ADDENDUM

ADDENDUM NO.: 01
PROJECT NAME: Sheridan Elementary School Annex
PROJECT NO.: 05075
CONTRACT NO.: C1581
DATE OF ISSUE: September 1, 2017

NOTICE OF CHANGES, MODIFICATIONS, OR CLARIFICATIONS TO CONTRACT DOCUMENTS

02 WALL SECTION
SCALE: 1/2" = 1'-0"

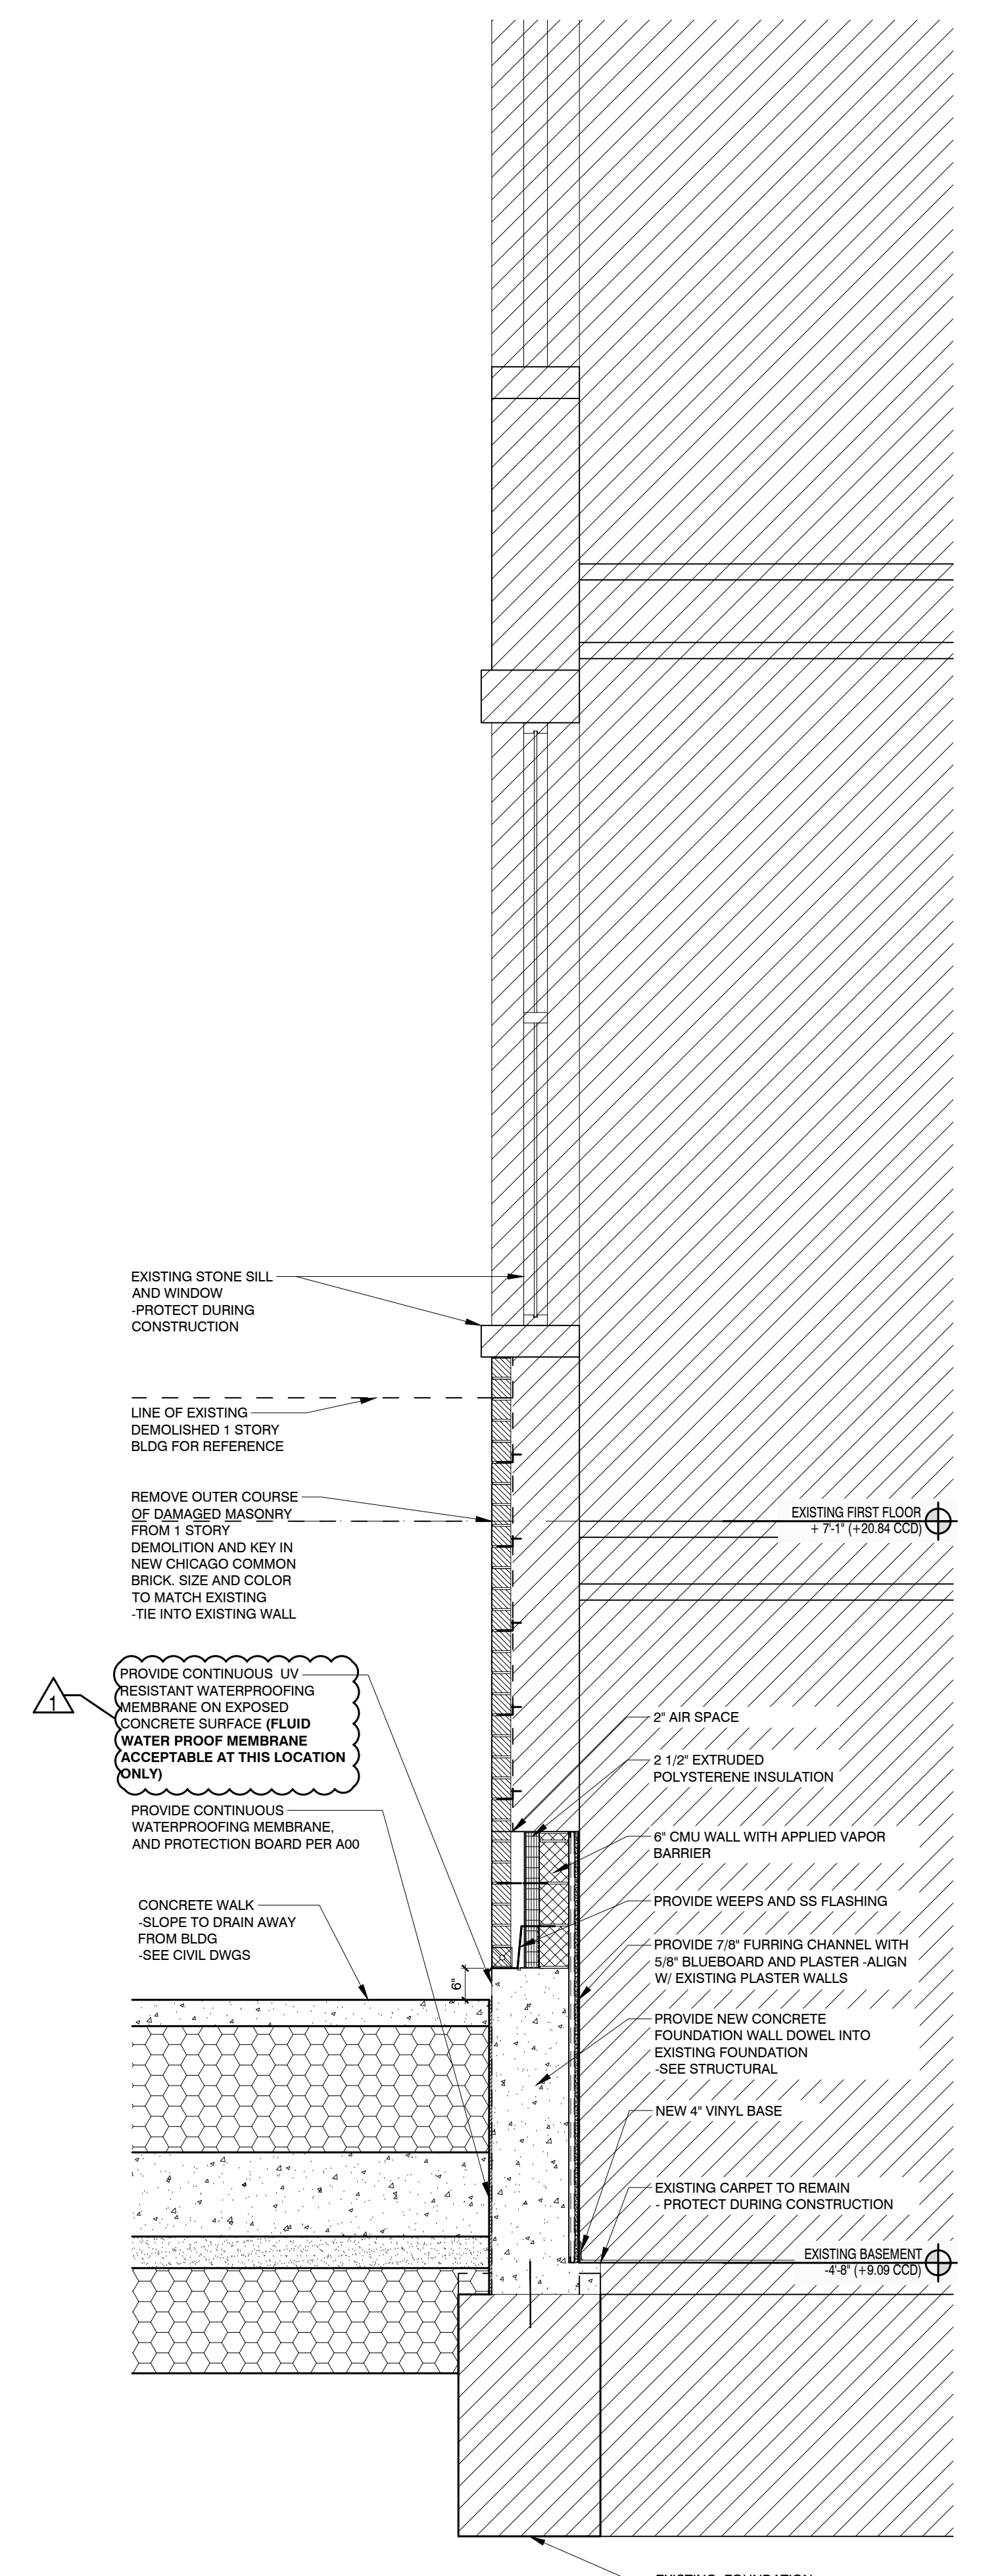
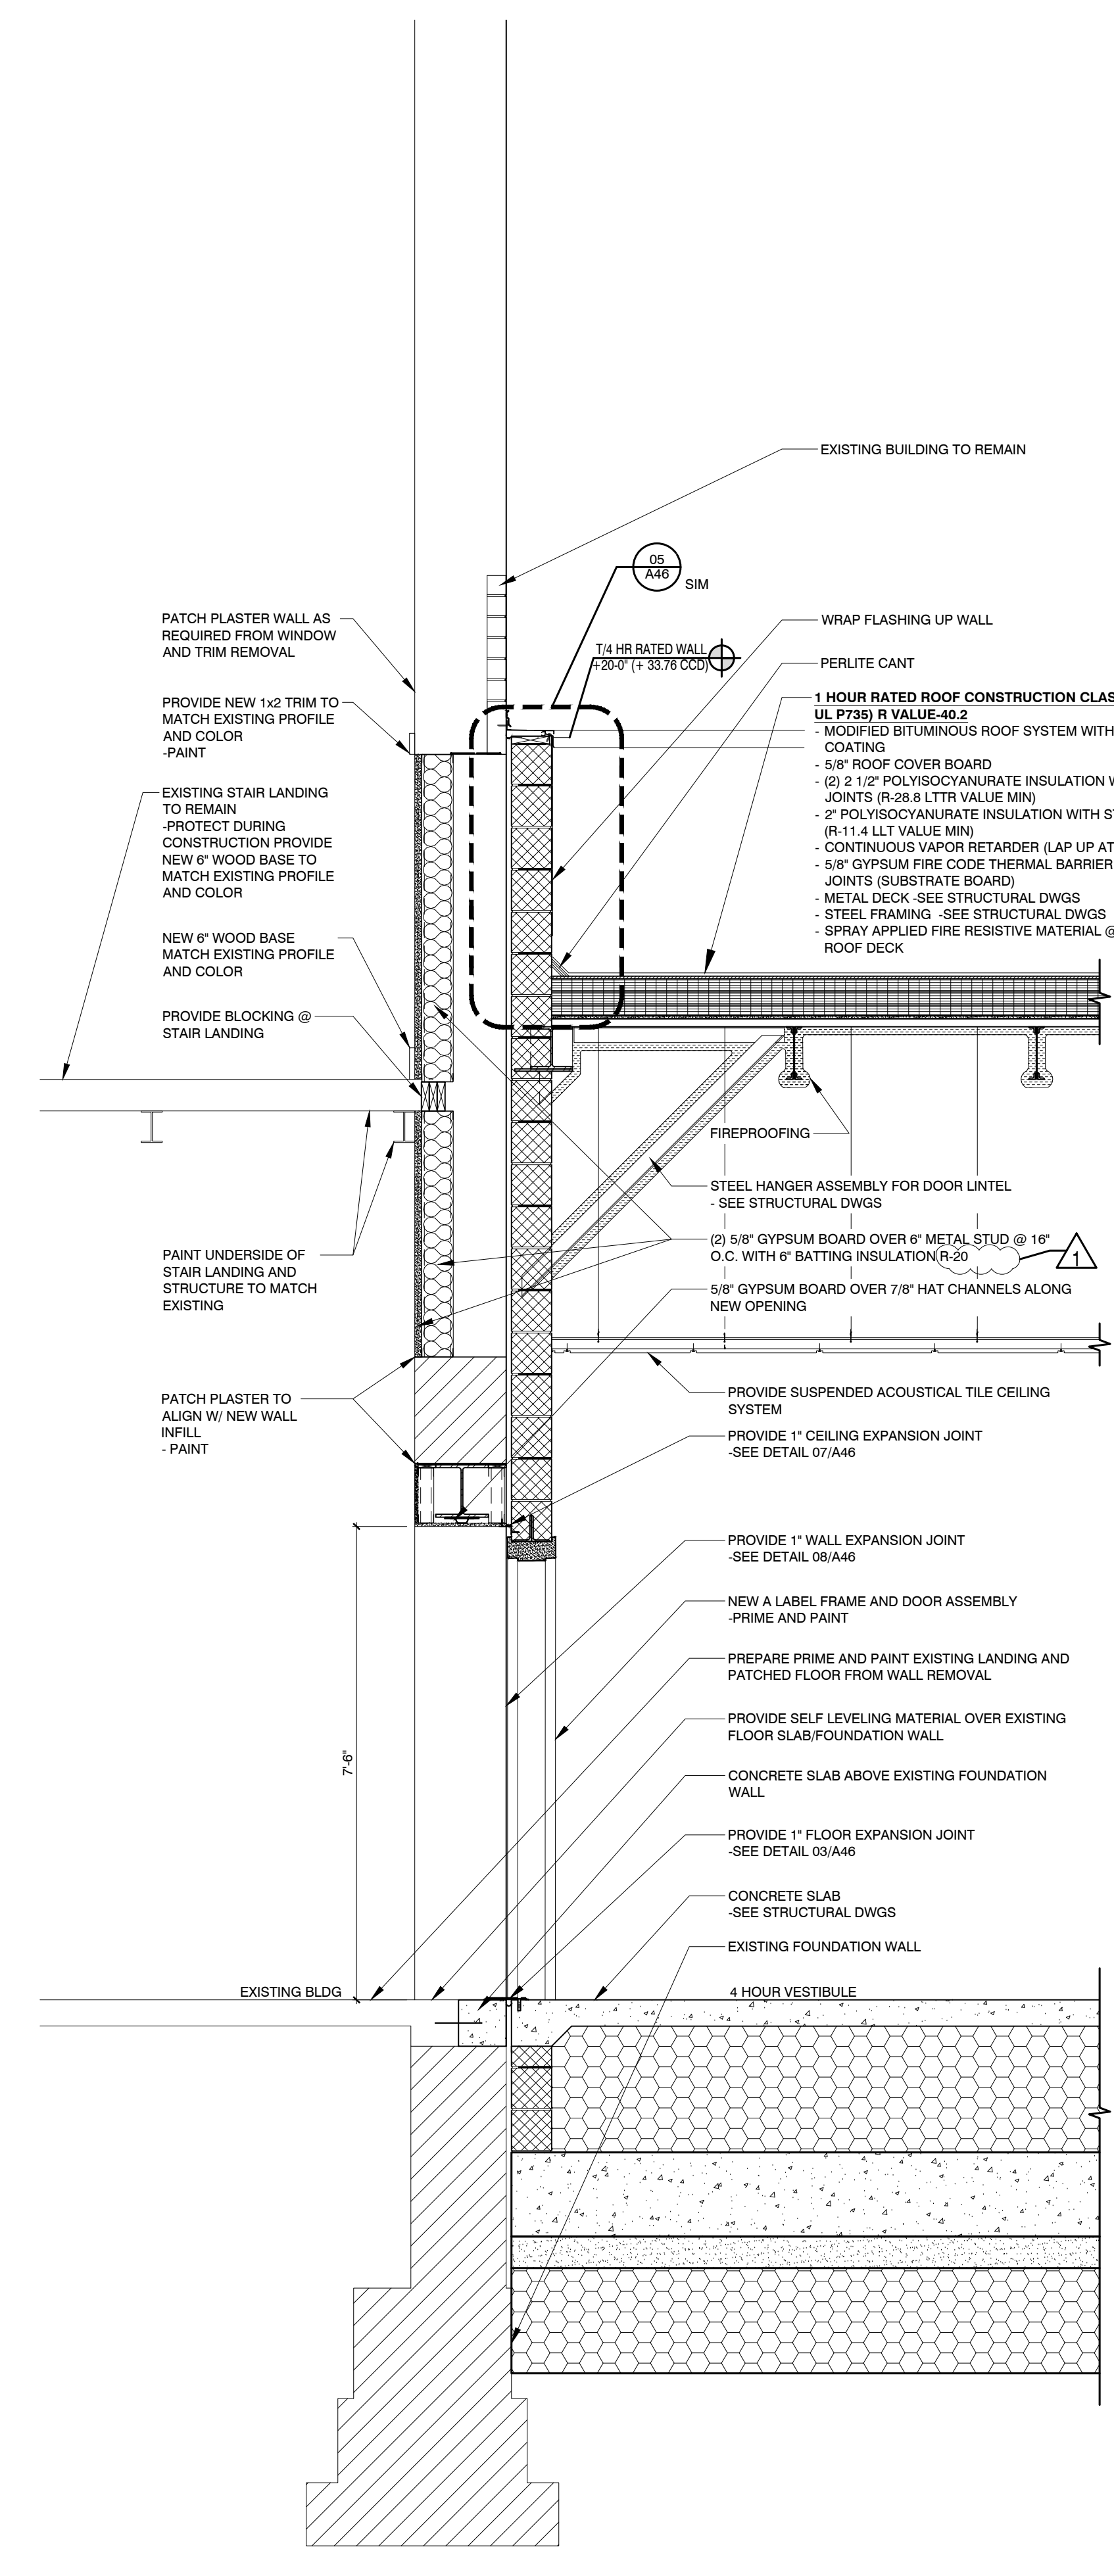
- Change 7. REVISED** – Drawing No. A32 – ELEVATOR SECTION & ELEVATOR DETAILS: Increased R value of insulated metal panels at elevator to R-20
- Change 8. REVISED** – Drawing No. A34 – WALL SECTIONS: Increased R value of insulated metal panels at elevator to R-20

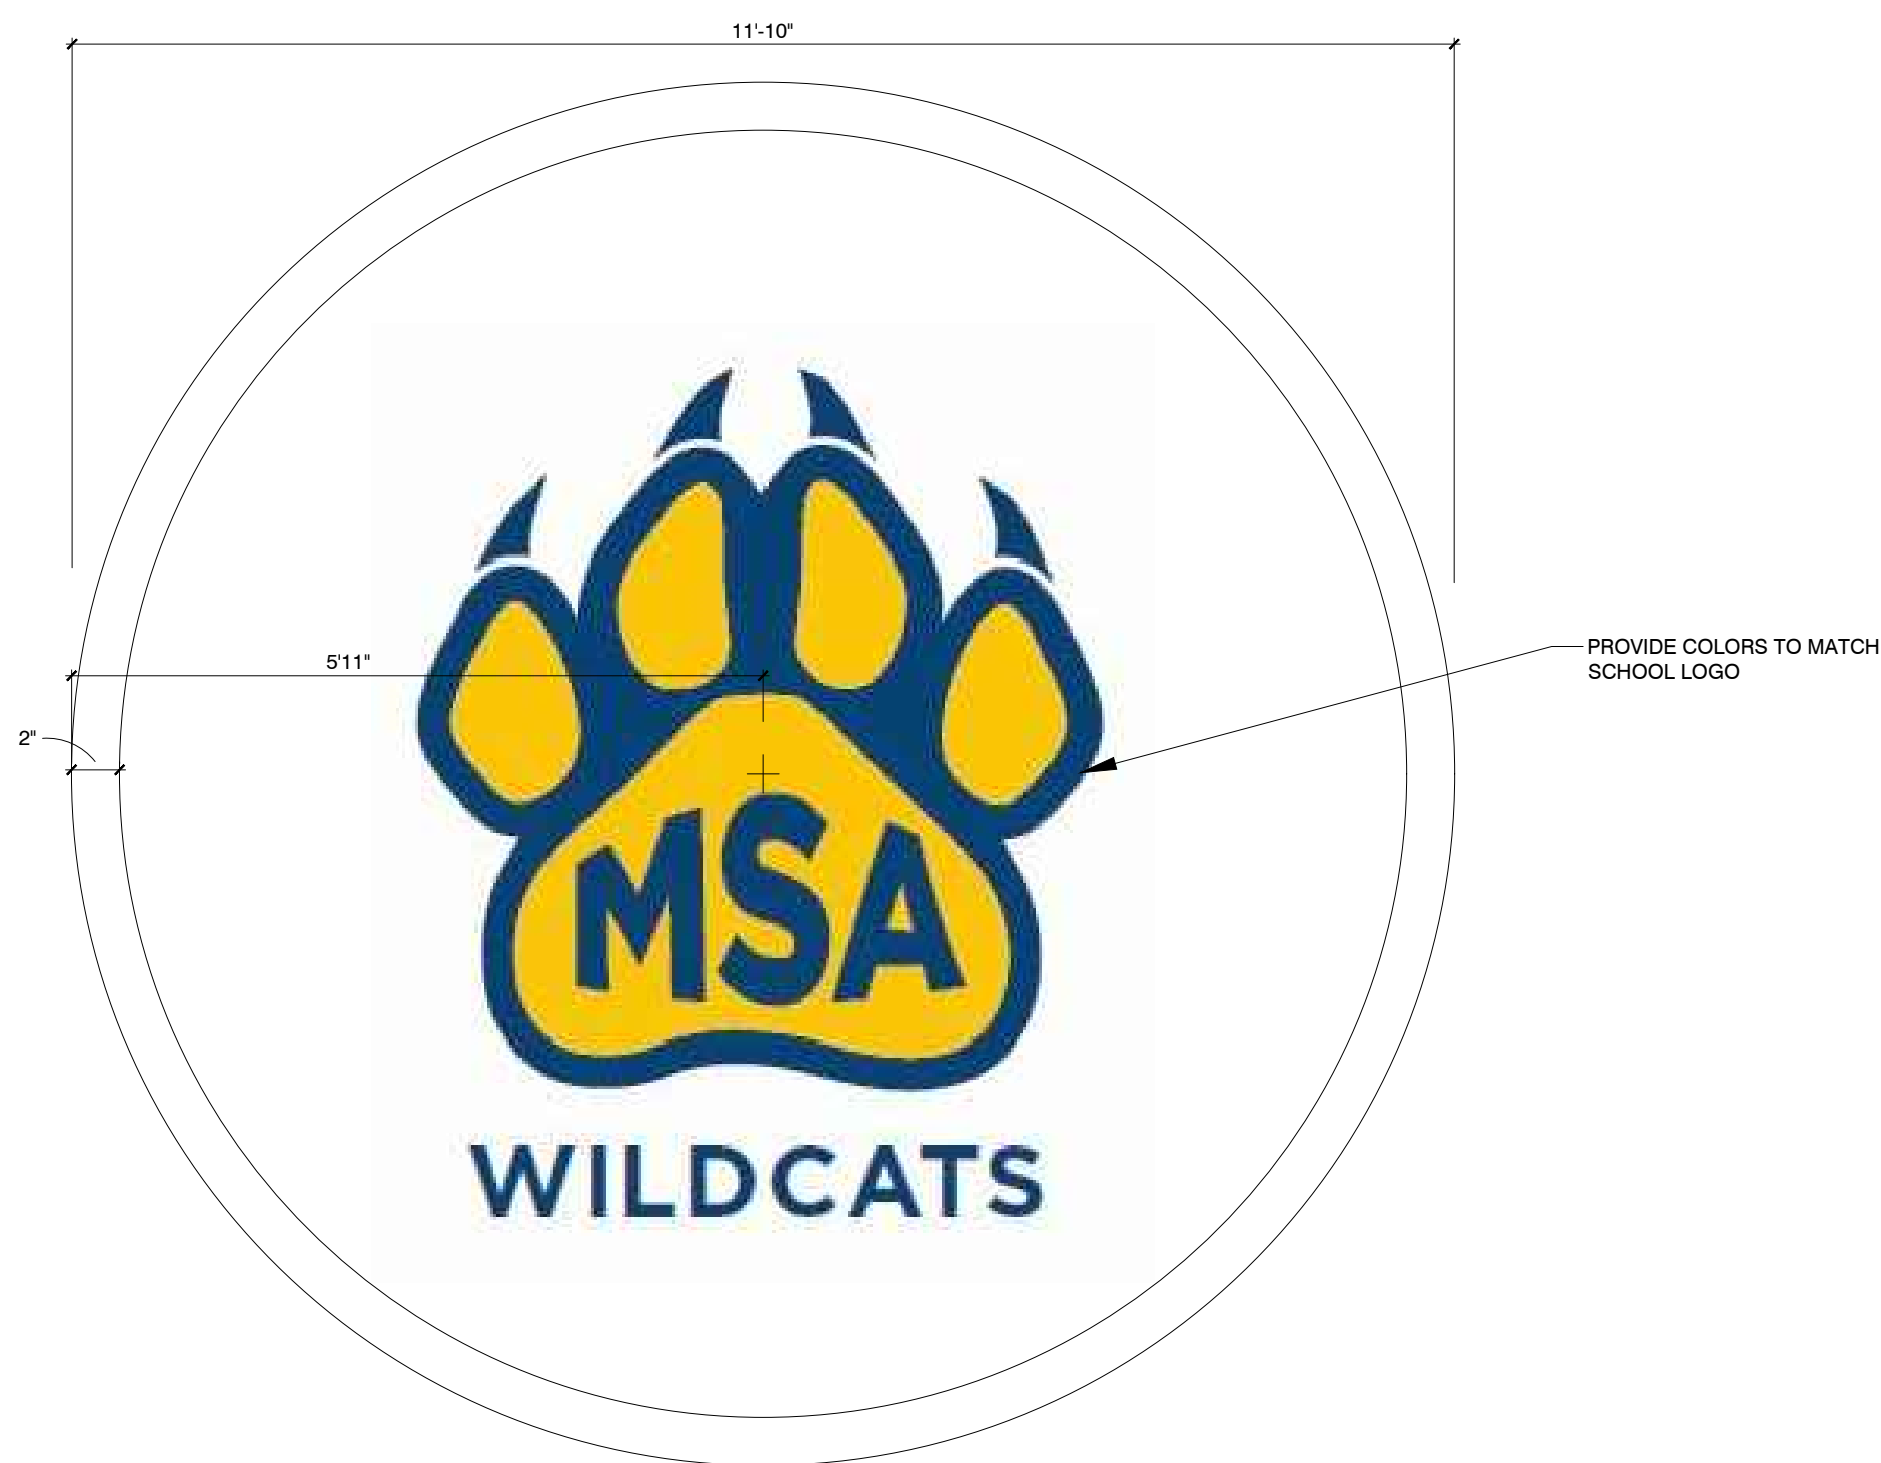
- Change 10. REVISED** – Drawing No. A62 – DOOR SCHEDULE: Changed door type of 121A to 04/A63 in lieu of 02/A63 to eliminate glazing.
- Change 11. REVISED** – Drawing No. A70 – FINISH SCHEDULES: Changed color of insulated metal panel in Color Schedule
